MODEL
2015-2016MY
Sedona (YP)

TECHNICAL SERVICE BULLETIN

SUBJECT: COMBINATION TSB / SERVICE ACTION:
A/C DISCHARGE HOSE REPLACEMENT (SA267)

This issue number is SA267.

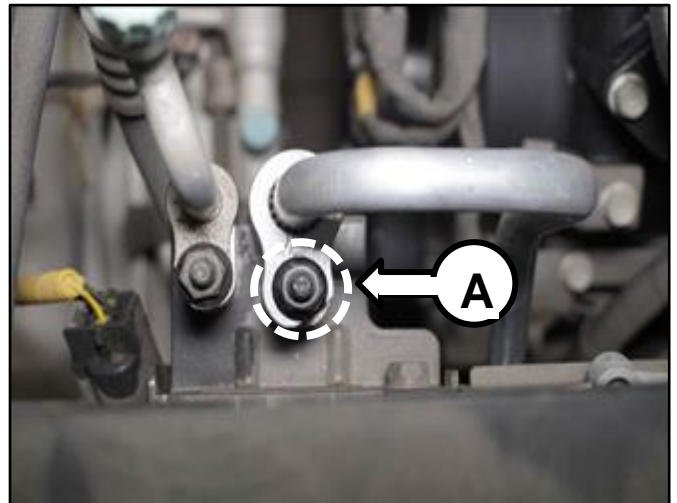
1. Recover the refrigerant by referring to the "Heating, Ventilation, Air Conditioning (Air Conditioner) → Air Conditioning System → Repair procedures" chapter in the applicable Work Shop Manual.
2. Record the customer's radio presets.
3. Remove the battery negative (-) terminal.
4. Loosen the nut (A) at the upper core support attaching the A/C discharge hose found.

Tightening torque:

5.1 ~ 8.0 lb-ft (6.9 ~ 10.8 N.m, 0.7 ~ 1.1 kgf.m)

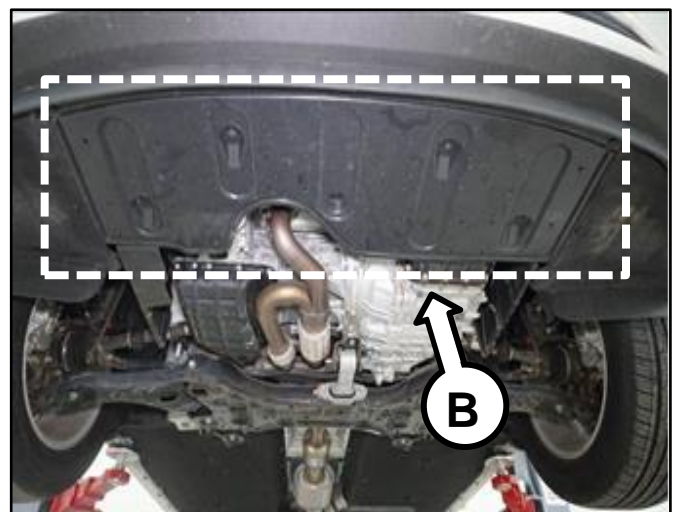
5. Raise the vehicle on a vehicle lift.
6. Remove the undercover (B).

2.9 ~ 4.3lb-ft (3.9 ~ 5.9 N.m, 0.4 ~ 0.6 kgf.m)

A/C Discharge Hose

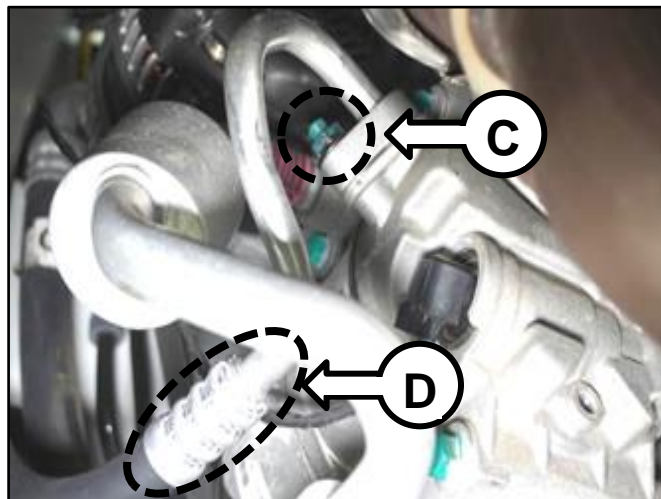
7. After loosening the nut (C) at the compressor discharge connection, remove the A/C discharge hose (D) and discard.

5.1 ~ 8.0 lb-ft (6.9 ~ 10.8 N.m, 0.7 ~ 1.1 kgf.m)

8. Install a new A/C discharge hose on the compressor and tighten/torque the nut.
9. Reinstall all removed components in the reverse order of removal, ensuring both ends of the A/C discharge hose are connected and the nuts are properly tightened/torqued.
10. Charge the system with refrigerant by referring to the "Heating, Ventilation & A/C (HVAC) → Air Conditioning System → Repair Procedure → System Charging procedures" chapter in the applicable Workshop Manual.
11. Confirm proper operation of the A/C system.
12. Reprogram the customer's radio presets, if necessary.
